# UNITED STATES PATENT AND TRADEMARK OFFICE

APPLICATION NO.	FILING DATE	FIRST NAMED INVENTOR	ATTORNEY DOCKET NO.	CONFIRMATION NO.
10/595,416	04/17/2006	Christian Herlt	HERL0101PUSA	9015
22045	7590	12/30/2008	EXAMINER	
BROOKS KUSHMAN P.C. 1000 TOWN CENTER TWENTY-SECOND FLOOR SOUTHFIELD, MI 48075			LAUX, DAVID J	
			ART UNIT	PAPER NUMBER
			4193	
			MAIL DATE	DELIVERY MODE
			12/30/2008	PAPER

<b>Office Action Summary</b>	<b>Application No.</b> 10/595,416	<b>Applicant(s)</b> HERLT, CHRISTIAN	
	<b>Examiner</b> David Laux	<b>Art Unit</b> 4193

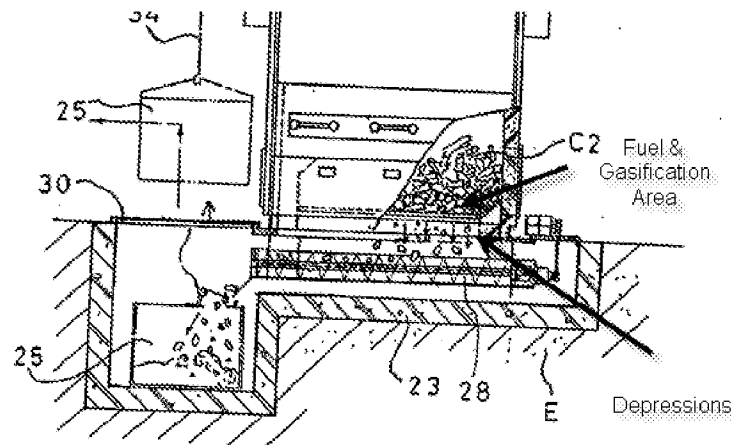
10. Claim 1, 3-4, 6, 9 & 11-12 are rejected under 35 U.S.C. 102(b) as being anticipated by WO 03/060039 (PGPUB US 2005/0051918 to Muramatsu et al is the national stage of this published international application and will be used as a translation thereof in the rejections that follow). '918 discloses a gasification boiler for solid fuels comprising: a fuel and gasification space (12) which can be closed by means of a filling door (29) and has air feeds (15), a grating (31) arranged at the bottom, a combustion space (13) situated below it, and ash separator (14), heat exchange surfaces (19) and fan (38) arranged behind it in terms of flow, characterized in that the

fuel and gasification space has depressions (see Fig. 4 reproduced in part below) for collecting ash laterally next to the centrally arranged grating and the combustion space; a cylindrical combustion chamber (16) is connected to the outlet of the combustion space (13); and a cylindrical ash separator (26) which is designed as an additional constructional unit and is connected to a known heat exchanger (19) and the combustion chamber (16), wherein the cylindrical combustion chamber (16) is connected at the bottom tangentially to the outlet of the combustion space (13) (Paragraph 0032), wherein the cylindrical ash separator (26) is connected at the top tangentially to the outlet of the combustion chamber (16), wherein a flue pipe is arranged centrally (17), wherein the ash separator can be closed at the top by a cover (30), wherein the cylindrical combustion chamber (16), the cylindrical ash separator (26) and the heat exchanger (19) are connected in a framework to form a constructional unit, wherein the cylindrical combustion chamber (16) is connected at the bottom tangentially to the outlet of the combustion space (13) and in that the combustion chamber (16) can be closed at the top by a cover, wherein the cylindrical ash separator (26) is connected at the top tangentially to the outlet of the combustion chamber (16).
